SEWAGE DISPOSAL SYSTEM

A REPAIR

SUBDIVISION Dogwood LOT 6 ROAD 6821 Redberry Road

REPAIR - PURPOSE - In anticipation of building permit. (Addition to include 4th bedroom)

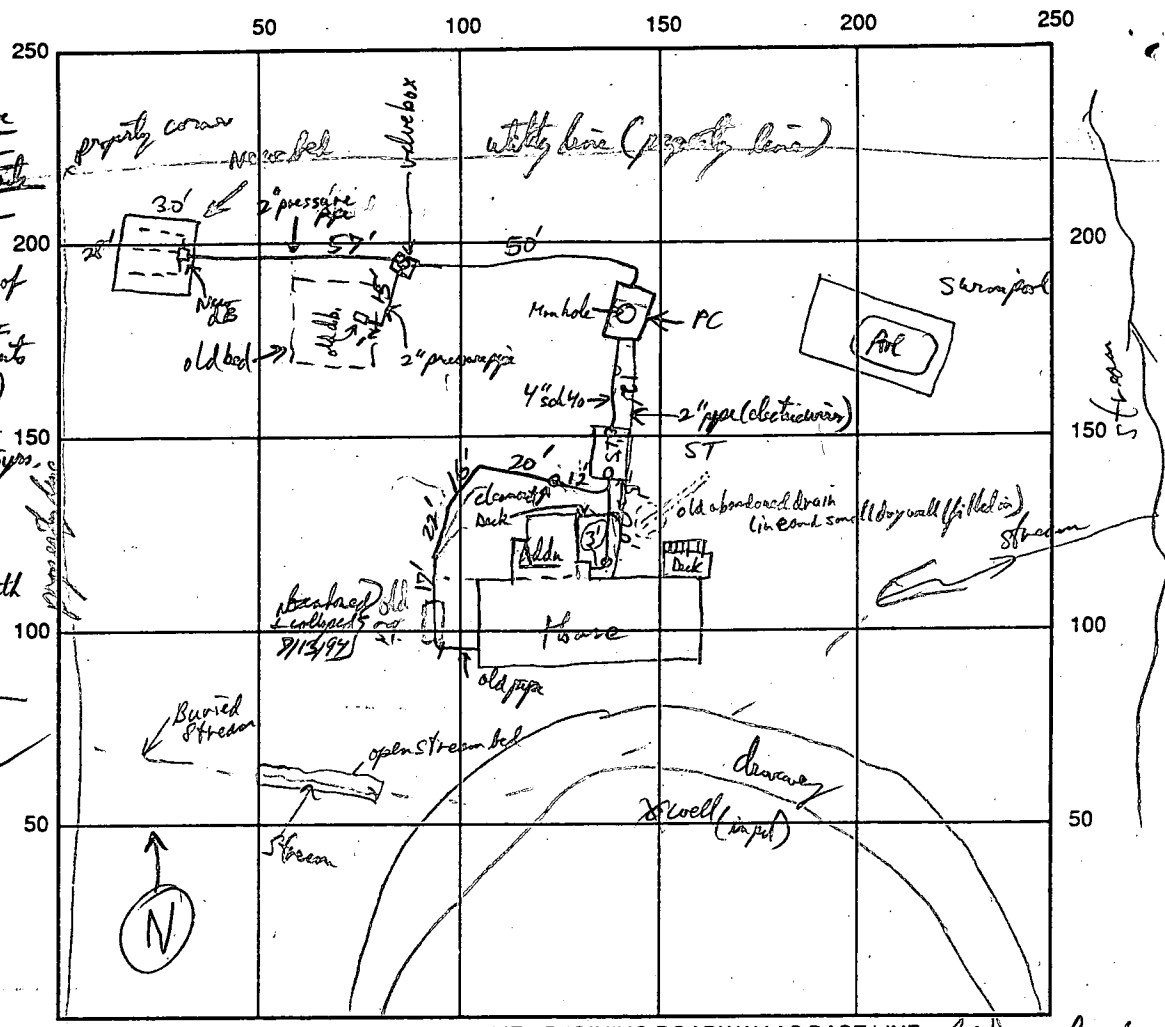
side view
to New Bed
to Old Bed
Manhole
Value
Box
Detail
Top view
To Old Bed
2" pipe inlet is on underside of Ball valve
When water goes to New Bed arrow on handle points Toward New Bed (west)
When water goes to Old Bed (recommended wait 4-5 yrs. before using) arrow should point back toward pump chamber.
Detail is a vertical 1" with inlet below outlet providing 180° apart.
Control box + alarm in Basement - OK

Notes: 1000 gal Top Seamed
 SEPTIC TANK LEVEL - 1500 gal Top Seamed, 2 chambers
 DISTRIBUTION BOX LEVEL (in Bed)
 DRAIN FIELD/TITLE DEPTH 5' high 1/4" low end Bed 30' x 28'
 TRENCH WIDTH _____ FT. INLET DEPTH _____ FT.
 EFFECTIVE GRAVEL DEPTH _____ FT. TOTAL LENGTH _____ FT.
 NUMBER OF TRENCHES _____ ONE SIDEWALL/BOTTOM AREA _____ SQ. FT.
 DRYWALL INSIDE DIAMETER _____ FT. EFFECTIVE DEPTH BELOW INLET _____ FT.
 ABSORBENT AREA _____ SQ. FT. Note: although Pump chamber is Not level, a level concrete platform was formed inside Pump chamber to provide a flat support for pump.
 REMARKS: OK to gravel fill Bed, Tank + PC are placed but Not piped. OK to cover HSE connection. 12/3/93 PJP
 (Fogle's) Contractor new work, Needs plans. No additional work done at this time. PC was not higher than new S.T.
 and New bed has been open 6 months, needs to be cleaned out before gravel placed. PJP 6/14/94 6/28/94 MWD
 and water at pump pit unstable, to inspect, no gravel + or no change

on new bed case (No new work). Not done 7/11/94 Needs level bottom where
 pump sits in pump chamber - level info via Tel. 7/13/94 Bed is OK to Over New Pump Test OK, old S.T. has been
 changed + collapsed OK to cover 7/13/94
 DATE SYSTEM APPROVED 7/13/94 INSPECTOR Inold Kelly

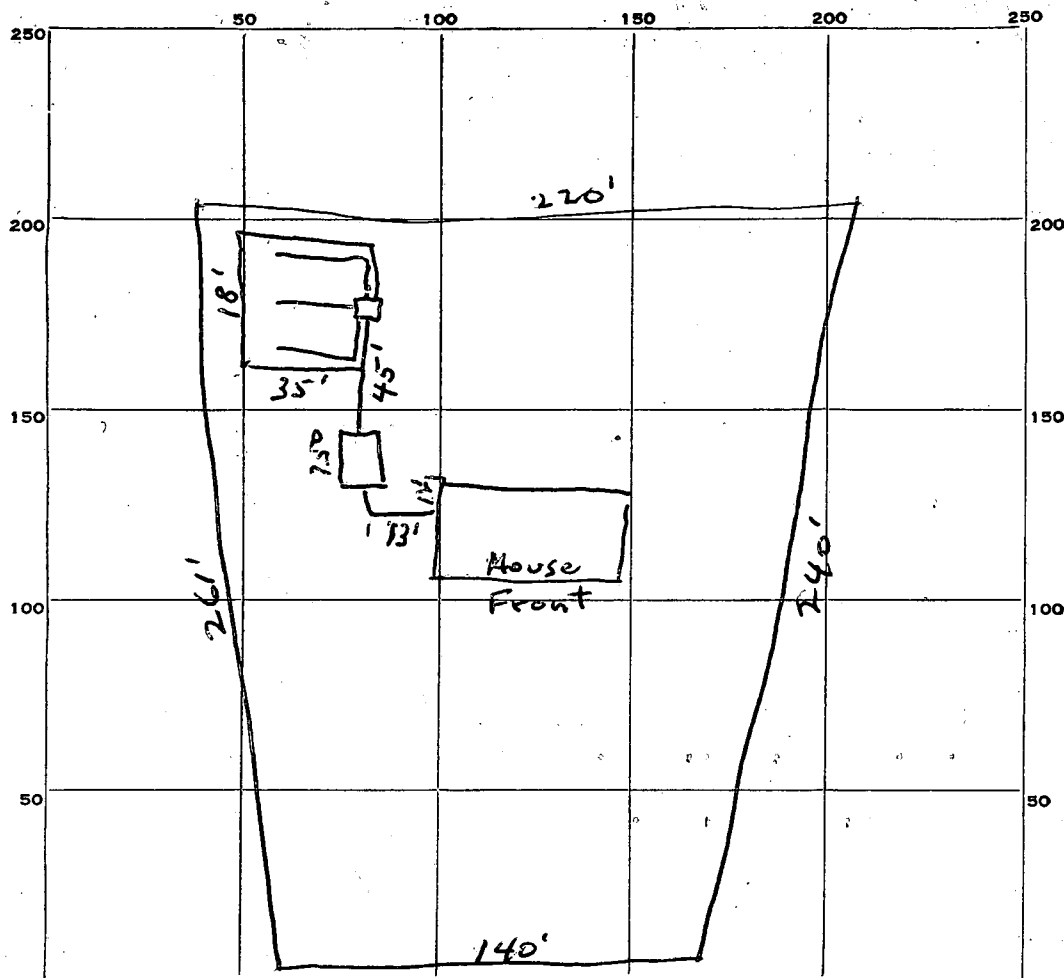
REMARKS ① Leaching Bed 5 1/2" to 7 1/2" deep below grade to bottom; specs. call for ~~4~~ no deeper than 4 ft. to bottom - Must be Retested; ② The inlet invert is now level with invert outlets, must be at least one inch above invert outlets; ③ All holes in distribution not in use must be sealed; ④ Inlet pipe into distribution box is not properly sealed - (3/30/65 - Bed is 4 ft below grade on lower part; upper part sealed - OK depth) R.F.

3/31/65 - Inlet pipe now correct - R.F.

Plat showing property known as #6821 Redberry Road, Howard County, Maryland. Also known as Lot 6 and the un-numbered lot between lots 6 & 7, as shown on the MAP OF DOGWOOD, which plat is recorded among the land records of Howard County in plat book R.H.M. 6, folio 82.

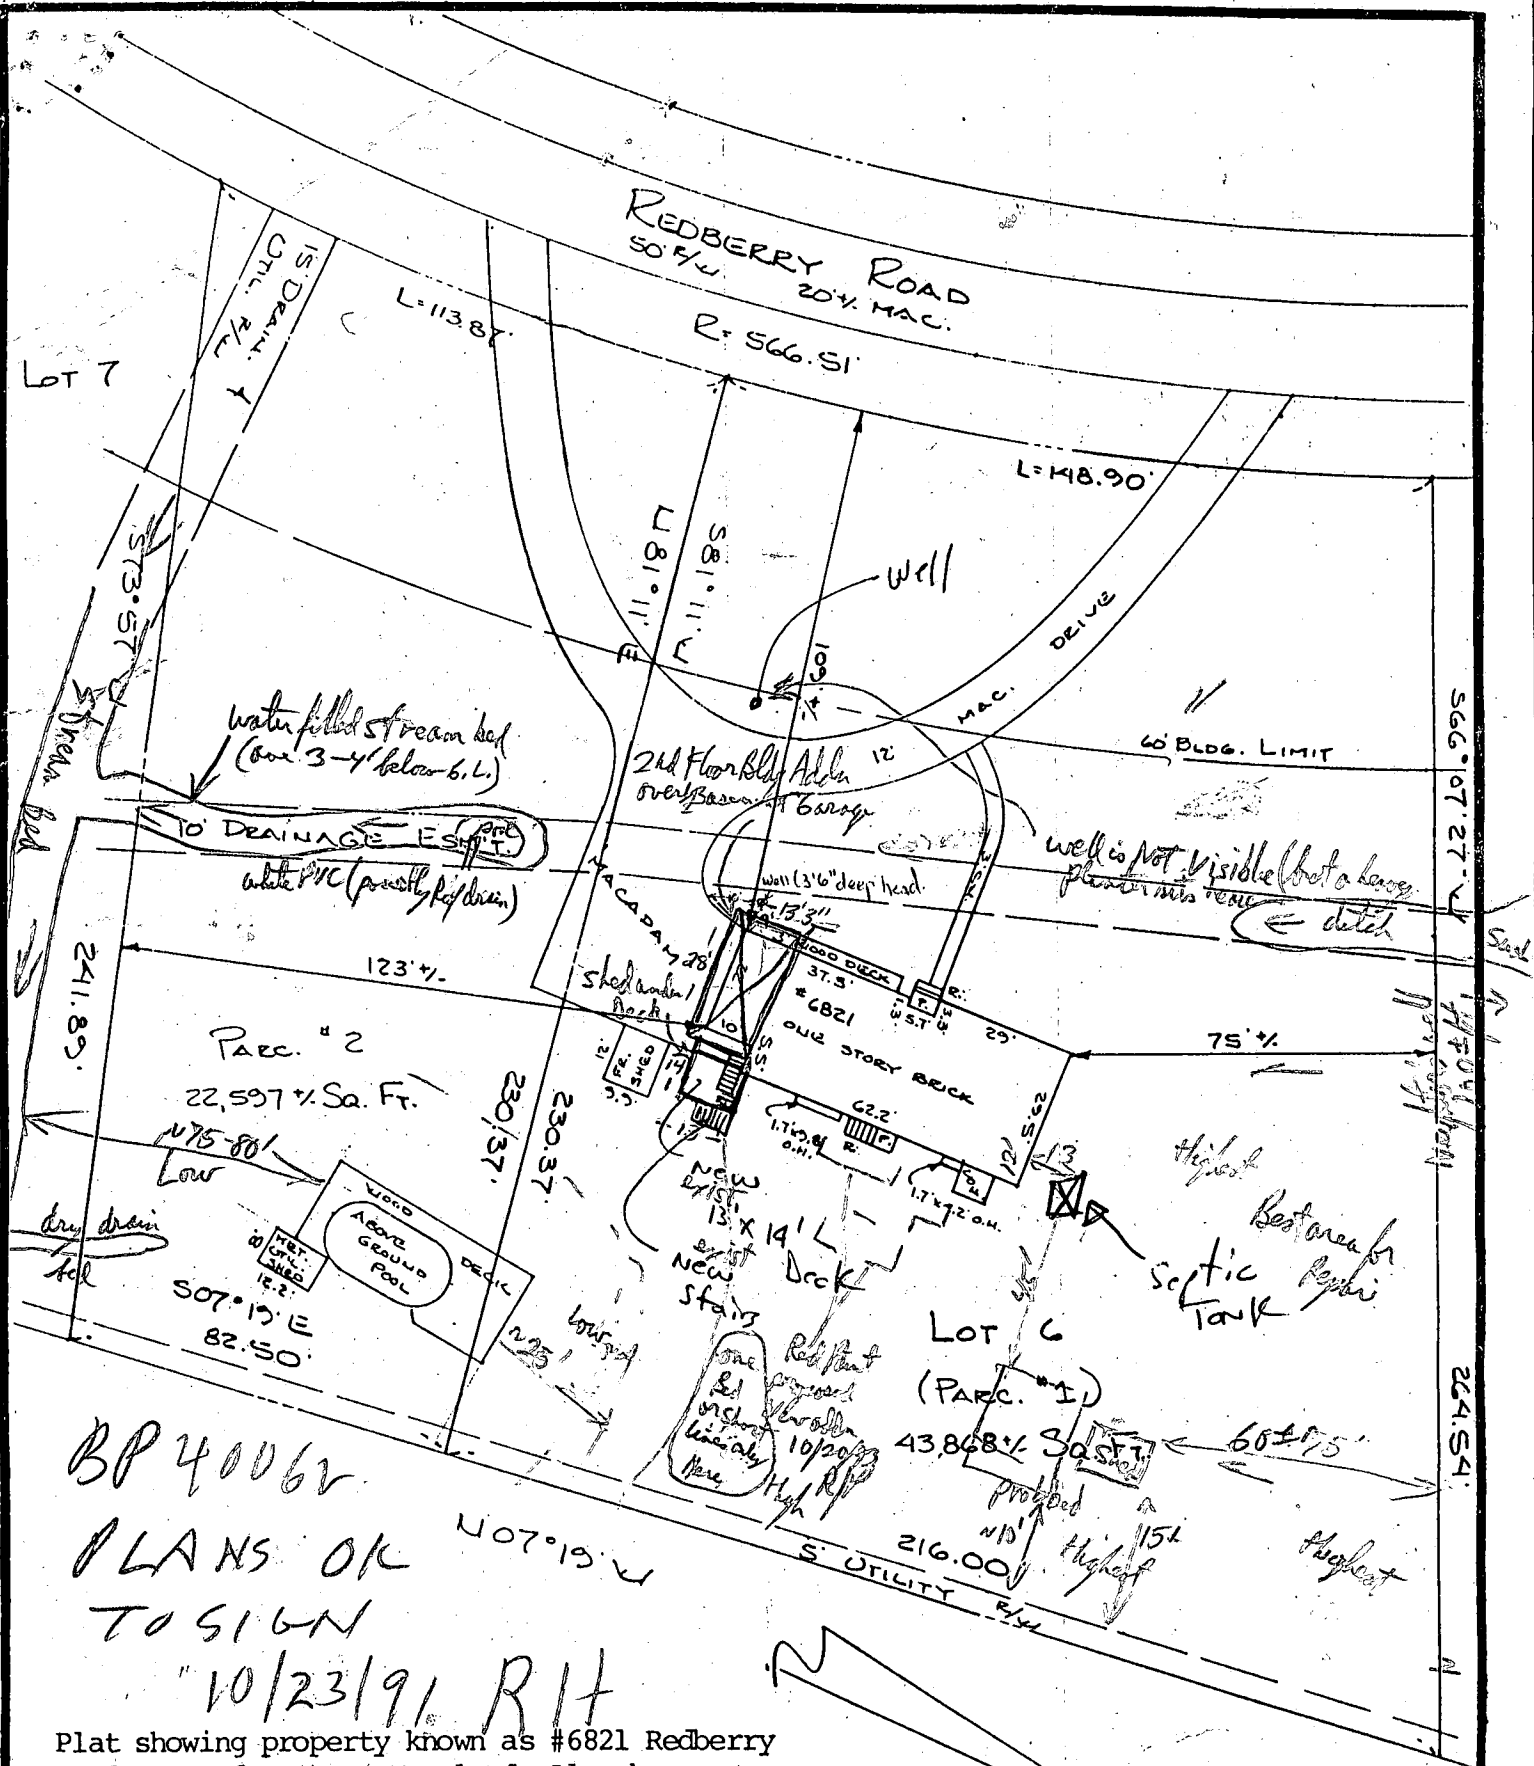
No elevations - well & septic not visibly verified (light fixtures where they shall be). - No evidence of failure.

There is from an ash for several trench or bed appears in high part of lot but only part appears to be highest me. Maybe 1 bed size area in back MID elevation Area low area too close to stream or pool.

Recommend
upgrading S.T. BALTIMORE, MARYLAND 21206
and one observation hole if Bed or Trench addition
is selected
